| WATER DESIGN                                                      |          |                                  |                          |
| Parcels 4 & 5<br>Hogwood Garden Village<br>Finchamstead, RG40 4QX |          |                                  |                          |
| NARS 27161                                                        |          |                                  |                          |
| X380-4-W-01                                                       | K        | 12                               | 1 of 1                   |

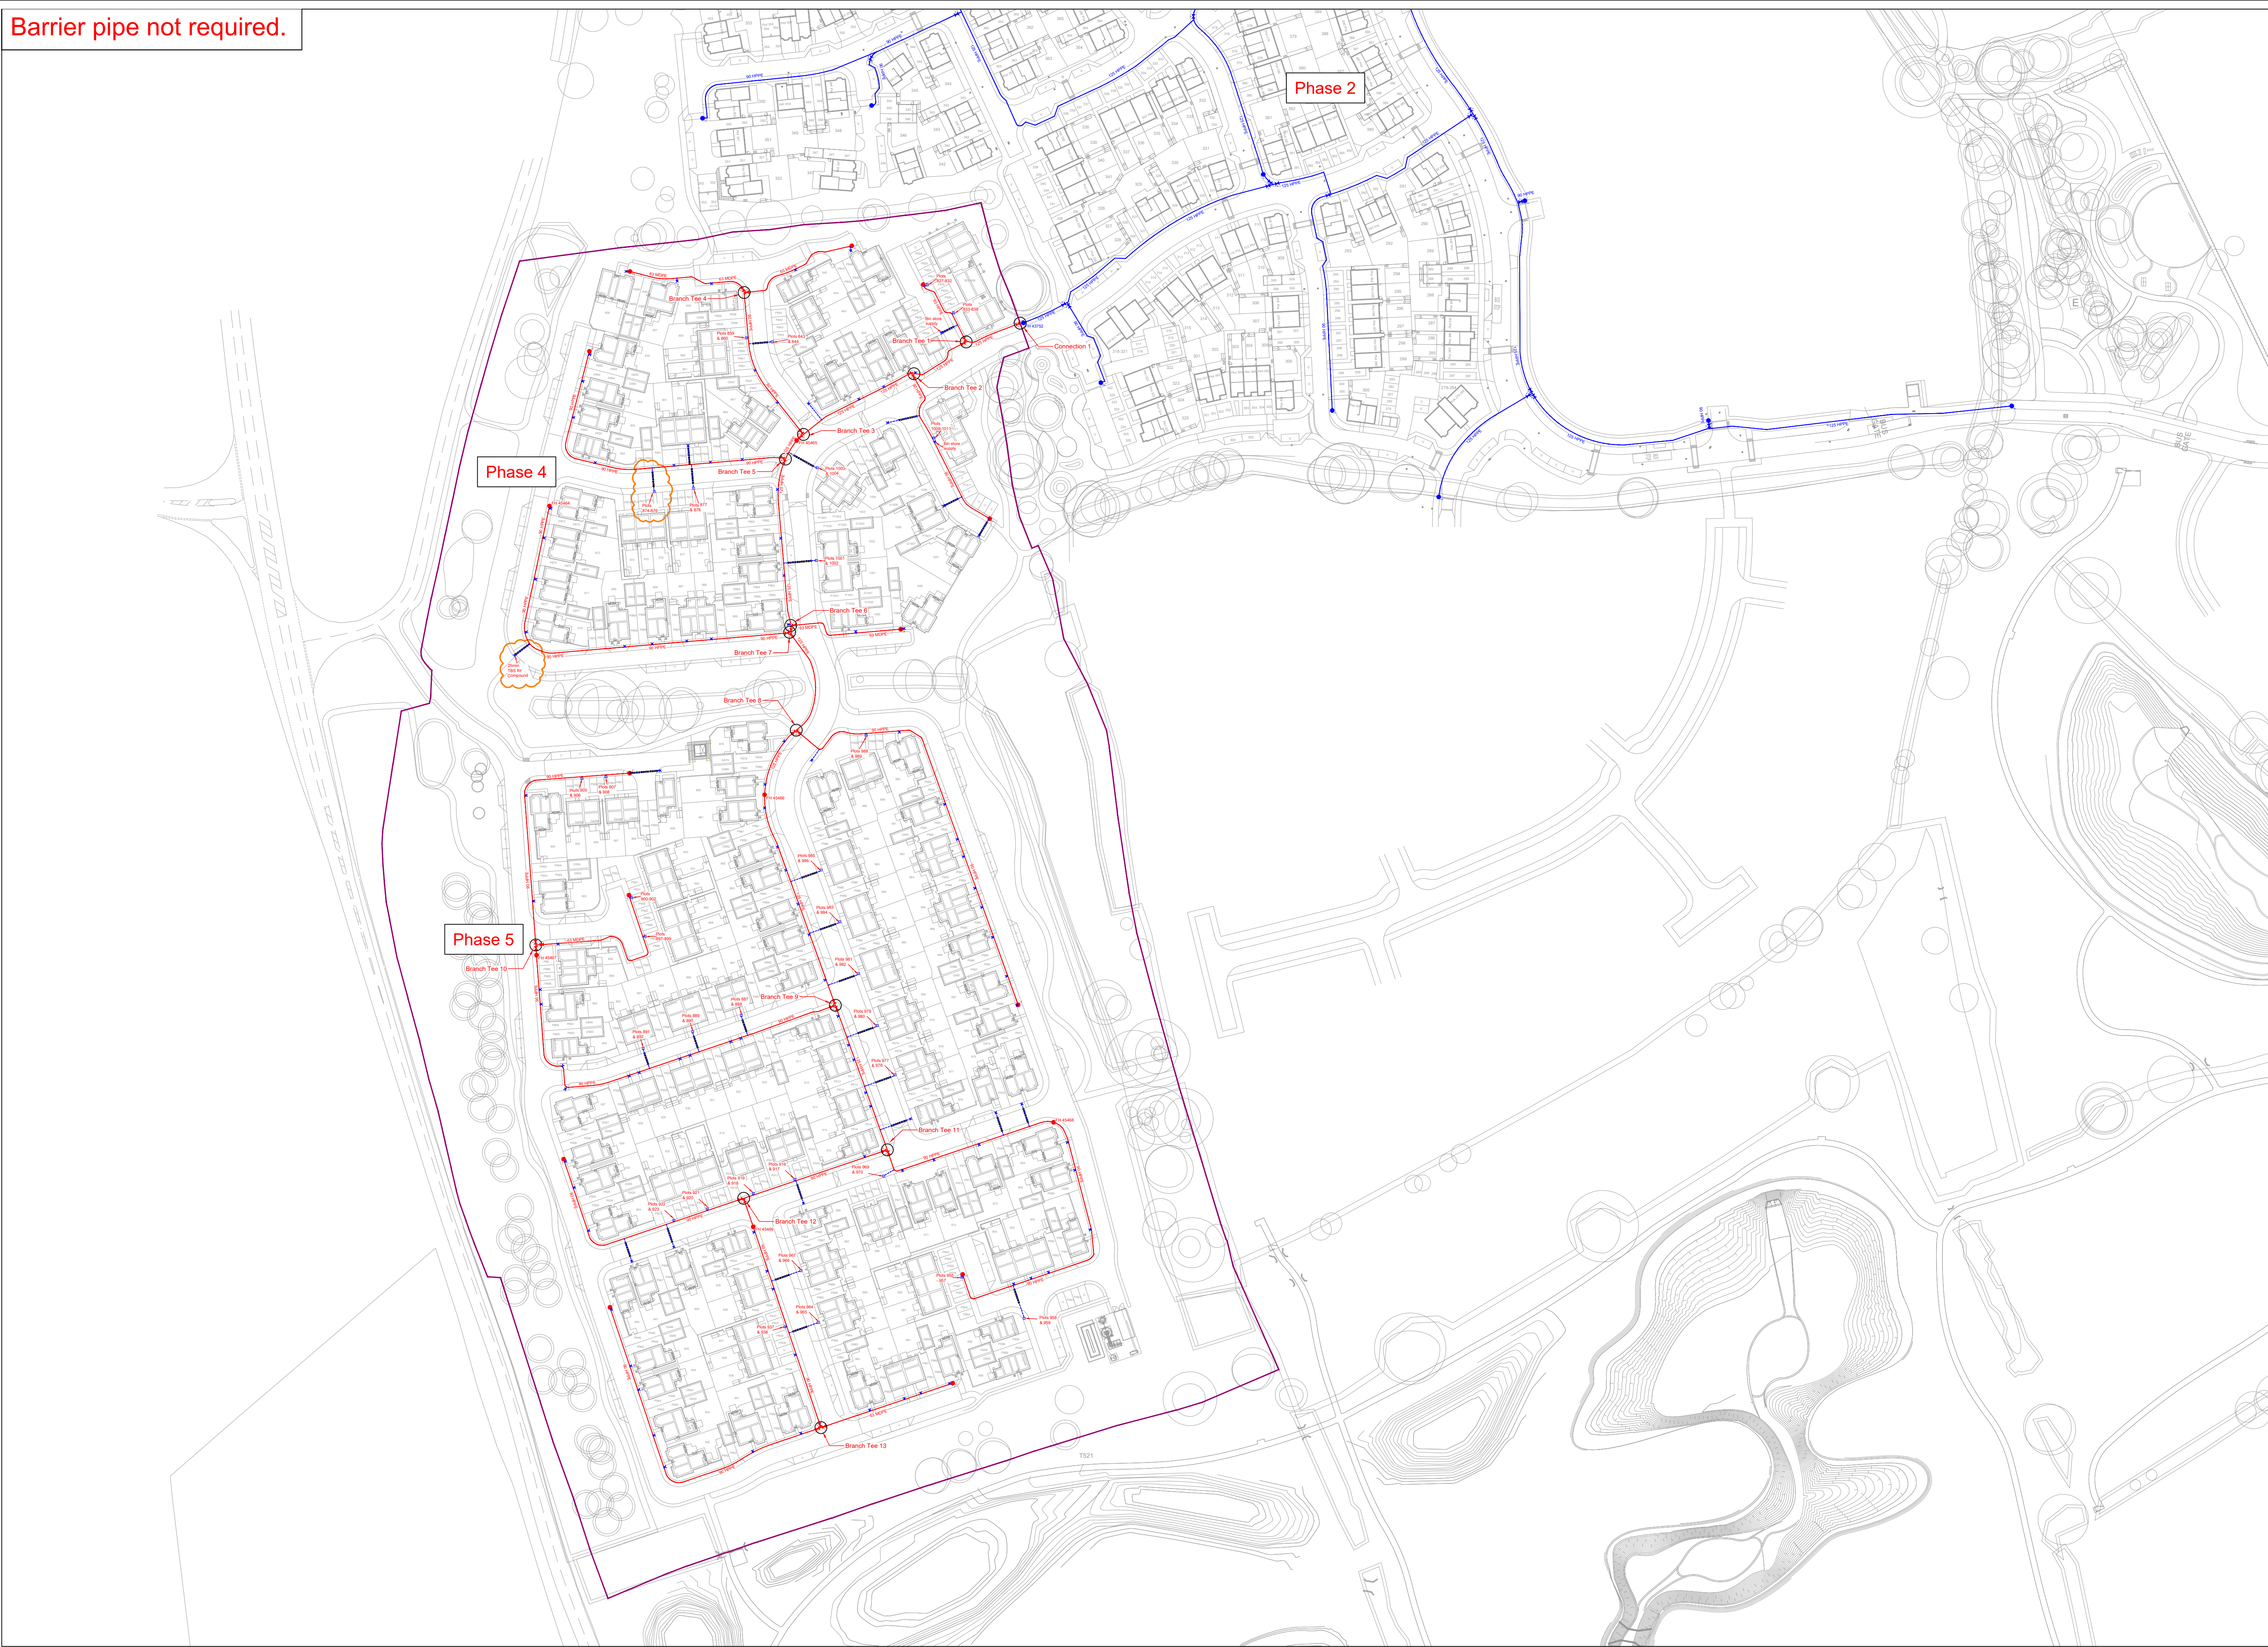
Barrier pipe not required.
